PRODUCT REVISION ANNOUNCEMENT

RELEASE DATE: 23/12/2011 - Document #6111223RO

This announcement contains the revised information about packaging for (2) index of Smart Ledbox, Illuminated Maxi Frame.

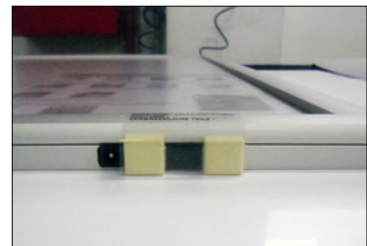
Switches under the bottom profile were regarded liable to get damaged during assembly or by mishandling.

With this revision, we place pads on both sides of the switch and cover it with a sticker. These pads are 8mm in thickness and protect the switch against damages. When you put unit on the floor, these pads keep the unit off the ground and the switch does not touch the floor. Also the sticker includes warning for the users about the fragility of switches.
